3/30/2022 (updated 4/15/22)

RE: Fiesta Ranch
5-PP-2022
J6117 (Key Code)

The Planning & Development Services Division has completed the review of the above referenced development application submitted on 2/17/2022. The following **1st Review Comments** represent the review performed by our team and is intended to provide you with guidance for compliance with city codes, policies, and guidelines related to this application.

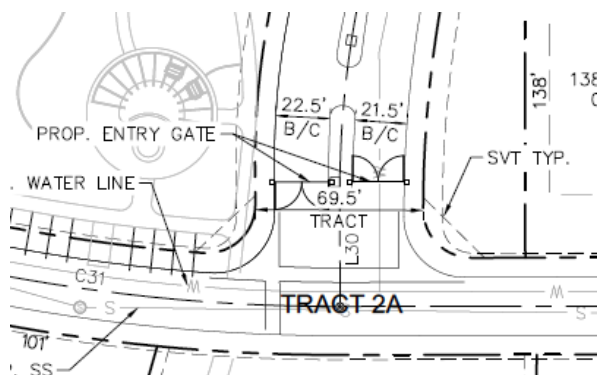
17. Please revise the transportation elements and street cross sections to conform to the Fiesta Ranch Master Circulation Plan, 1-MP-2021, and approved zoning case 6-ZN-2019. **ADDRESSED**
18. Intersection skews are allowed up to 4%, but anything greater requires Transportation Department approval. Please verify and confirm that the intersections along the East/West collector street are in compliance, per DSPM 5-3.123. **ADDRESSED**
19. Gated entrances must conform to DSPM Sec. 2-1.302, Fig. 2-1.2. The gates shown below are not set back far enough. Please revise the gated entry configuration(s) accordingly.

Gated entry configuration have been revised.
